TITLE	PARTIAL MEZZANINE/LOW ROOF FRAMING PLAN - AREA B (SEQ-1)		
MADE BY	DATE	CONTRACTOR	JOB No.
PDS	11/30/2020		20028
CHKD BY	DATE	ARCHITECT	ENGINEER
JSY	11/30/2020		
			SHEET NO.
			1E1
			REV.
			A

**PARTIAL MEZZANINE/LOW ROOF FRAMING PLAN @ AREA-B (SEQ-1)**  
 (REF: S2.2 & 1/A1.3)  
 [TOP OF STEEL ELEVATION 114'-0 1/2" U.N.O.]

TITLE	BRACE ELEVATIONS @ AREA-B			JOB No.
MADE BY	DATE	CONTRACTOR	20028	
CHKD BY	DATE	ARCHITECT	ENGINEER	SHEET NO.
JSY	11/30/2020			1E7
				REV. A

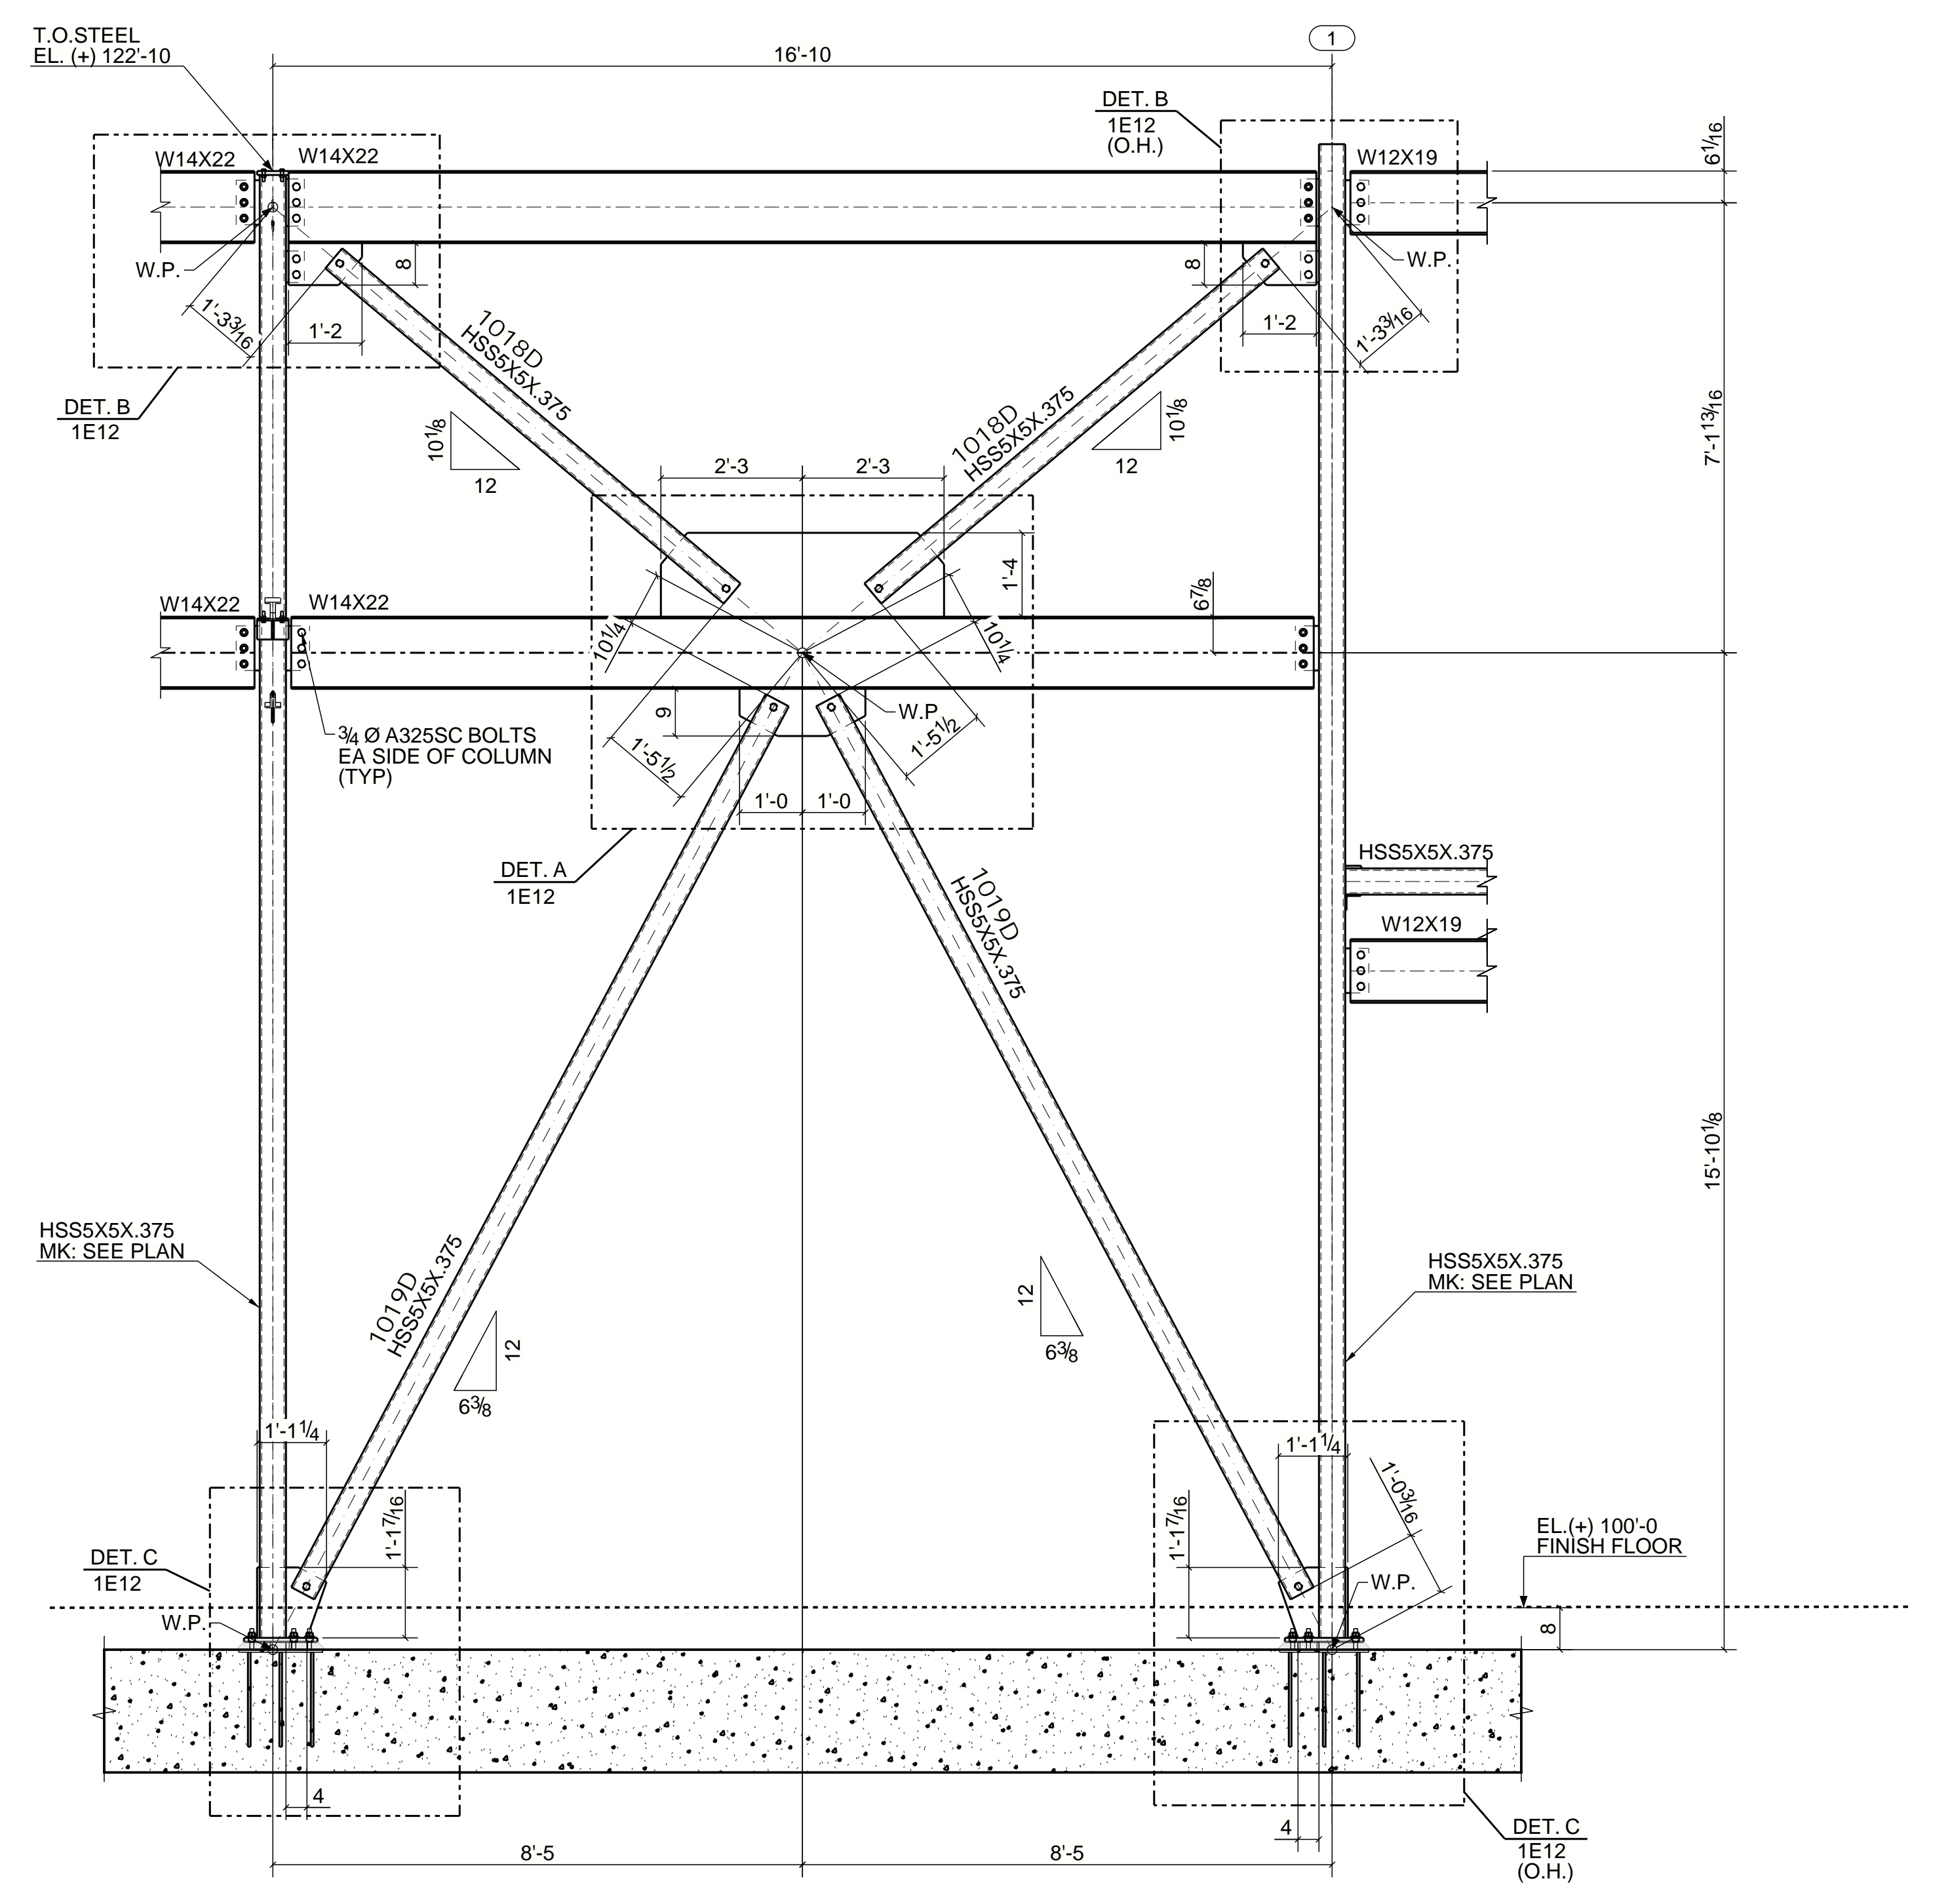
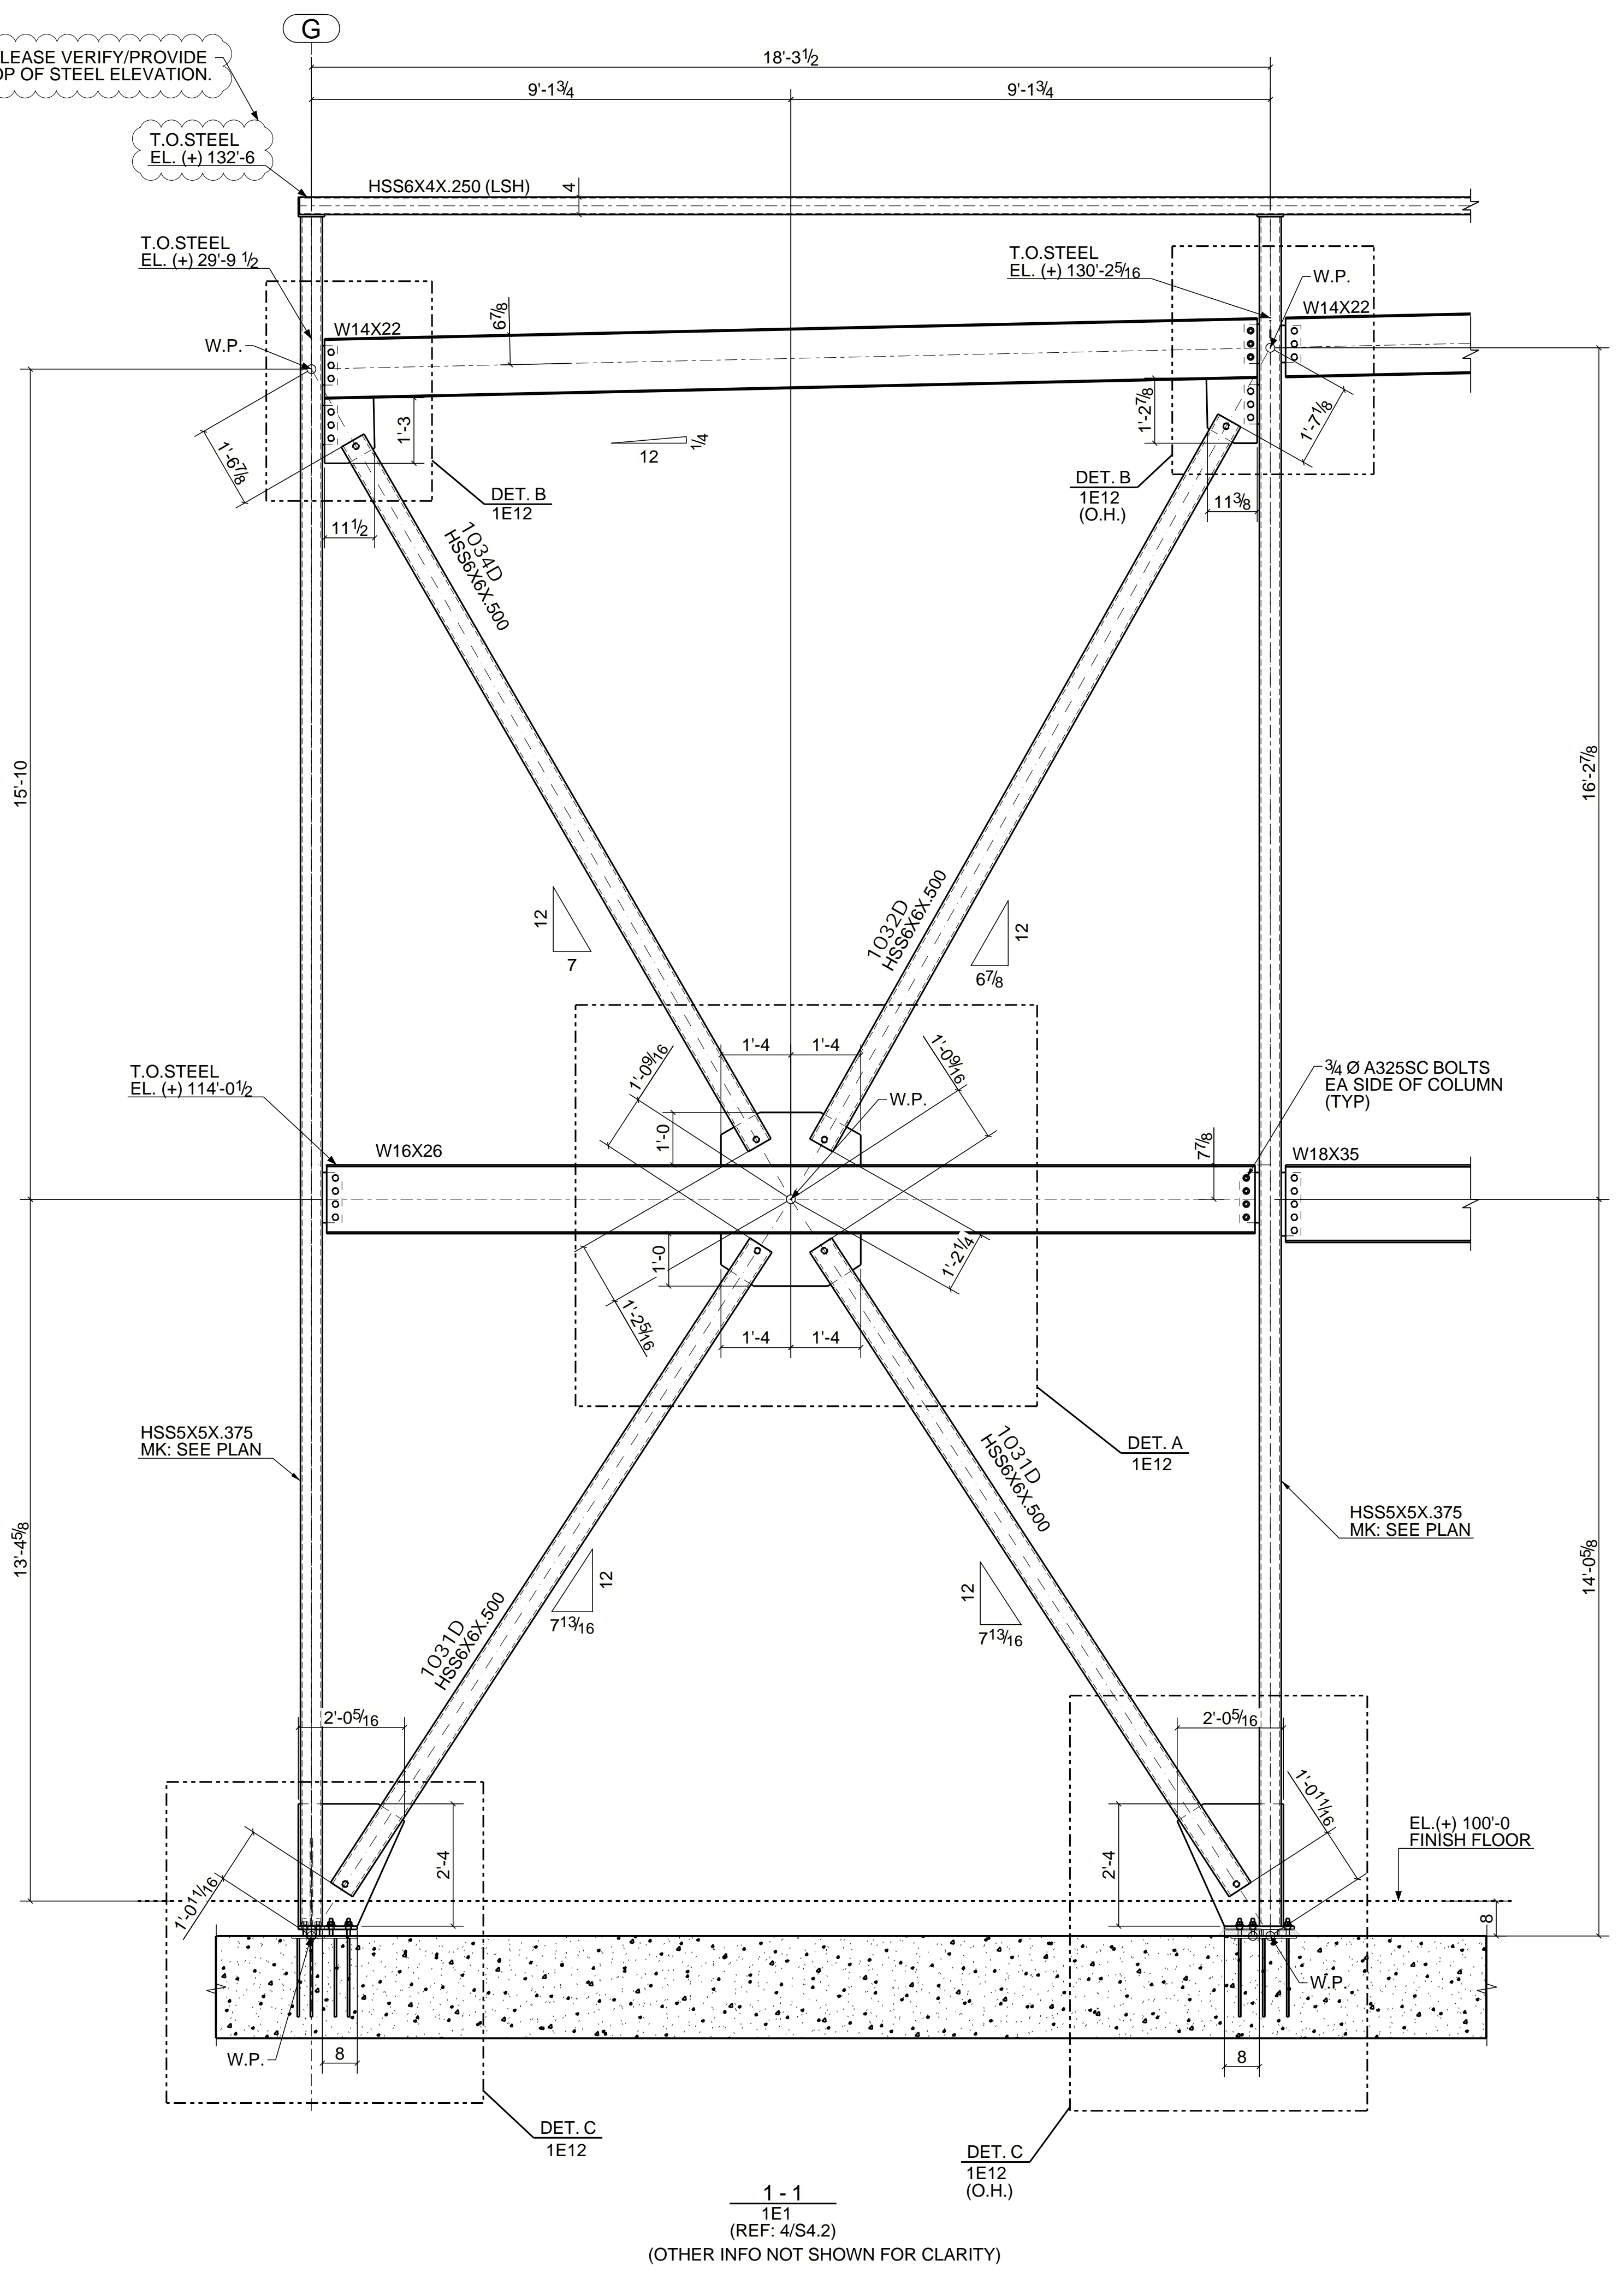
PLEASE VERIFY/PROVIDE TOP OF STEEL ELEVATION.
